Hingham Planning Board
Town of Hingham
210 Central Street
Hingham, MA 02043

Re: 22 Howe Street – Site Plan Review Request for Comprehensive Assessment of Tree Removal, Drainage, Wind and Canopy Impacts

Exhibit A – Photographs of 22 Howe Street, Pre and Post Clearing

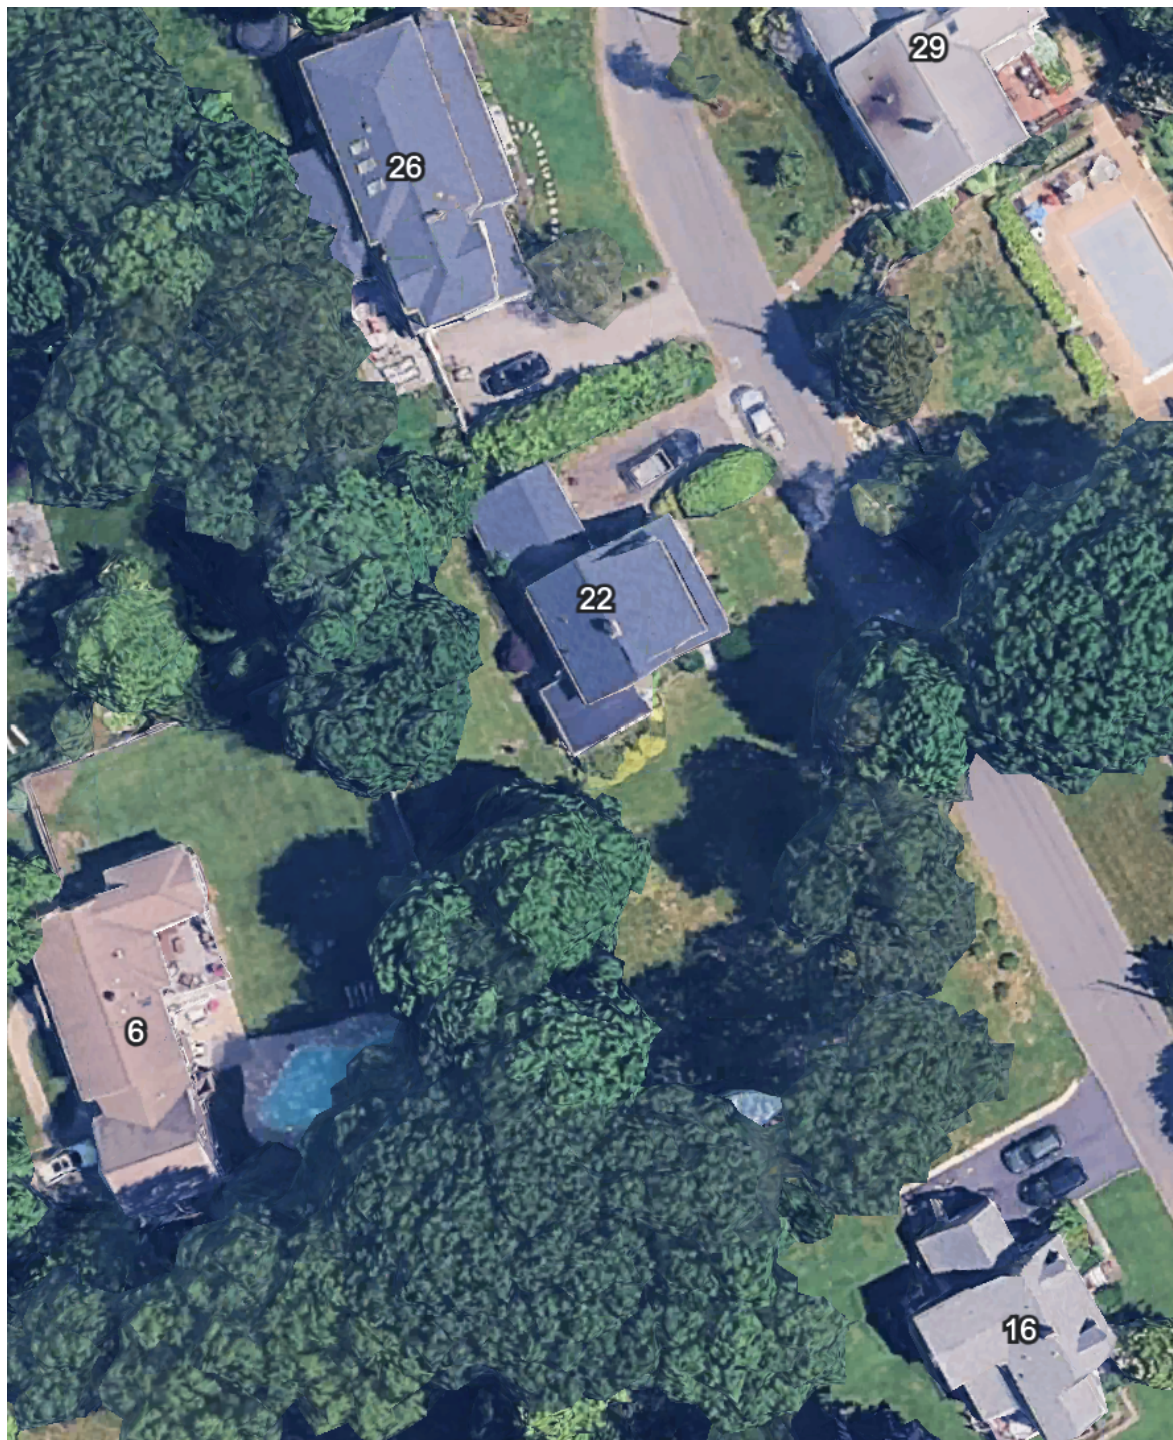
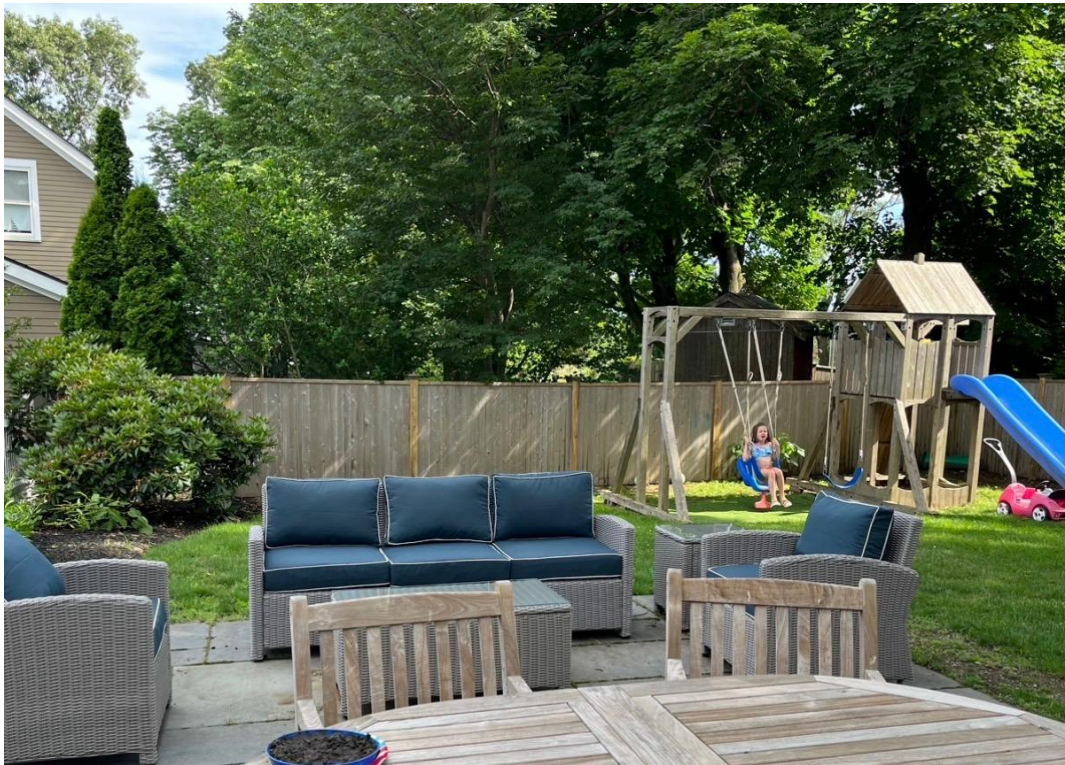
Exhibit A – Pre-Clearing Condition shows a substantial, continuous mature tree canopy along the boundary between 22 Howe and neighboring properties, including large mature trees, smaller trees, and understory vegetation. Post-Clearing Condition shows the removal of the mature canopy and much of the boundary vegetation, leaving the property substantially exposed.

We therefore respectfully request that the Board use the reasonably documented condition immediately before the clearing—not the already-cleared condition—as the baseline for determining whether the proposed project and mitigation measures satisfy the intent and requirements of Site Plan Review.
